4 SUB2015-00061

DORIS DAVIS FAMILY DIVISION SUBDIVISION

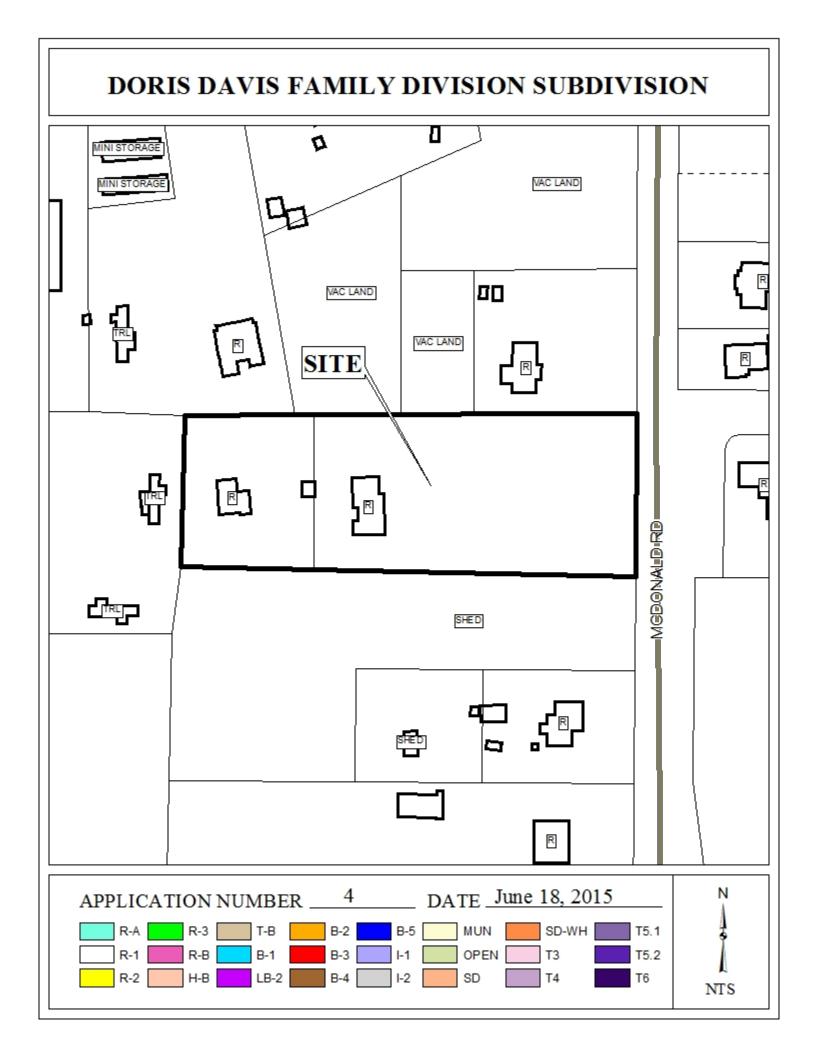
The proposed lots front McDonald Road, a planned major street as shown on the Major Street Plan Component of the Comprehensive Plan. As a proposed major street, this street requires a 100' wide right-of-way width. The existing right-of-way width is depicted as 60' on the preliminary plat, thus dedication is required to provide 50' from the centerline.

In accordance with the Subdivision Regulations, the proposed lots appear to exceed the minimum lot size requirements for lots with public water and individual septic systems, even after the dedication of right-of-way. The lot size information is depicted in square feet and acres on the preliminary plat and should be retained on the Final Plat, if approved, with revision for dedication for each lot.

The 25-foot minimum building setback line is depicted on the preliminary plat and should be retained on the Final Plat, if approved, revised to reflect dedication.

As a means of access management, a note should be placed on the Final Plat stating that the proposed lots are limited to 1 curb-cut each to McDonald Road, with the size, design and location of the new curb-cuts to be approved by Mobile County Engineering and conform to AASHTO standards.

Lots 2 and 3 are irregularly shaped and will require a waiver of Section V.D.1 of the Subdivision Regulations. The applicant's justification for the flag lots is that the proposed shape of the lots are configured to accommodate the existing dwellings on both Lots 2 and 3 and to bequeath Lot

1 to their grandchild for future development. As there are other irregularly shaped flag lots in the vicinity that have been approved by the Planning Commission, and as this is a family subdivision, a waiver of Section V.D.1 may be appropriate.

Due to the irregular shapes of Lots 2 and 3, a note should be placed on the Final Plat stating that there shall be no further subdivision until additional frontage on a paved public or private street is provided.

- 1) Dedication sufficient to provide 50' from the centerline of McDonald Road;
- 2) Retention of the lot size information on the Final Plat, revised for dedication;

- 3) Revision of the 25-foot minimum building setback line to reflect dedication;
- 4) Placement of a note on the Final Plat, if approved, stating that the proposed lots are limited to 1 curb-cut each to McDonald Road, with the size, design and location of the new curb-cuts to be approved by Mobile County Engineering and conform to AASHTO standards;

- 5) Placement of a note on Final Plat stating that there will be no future subdivision of Lots 2 and 3 until additional frontage on a paved public or private street is provided;
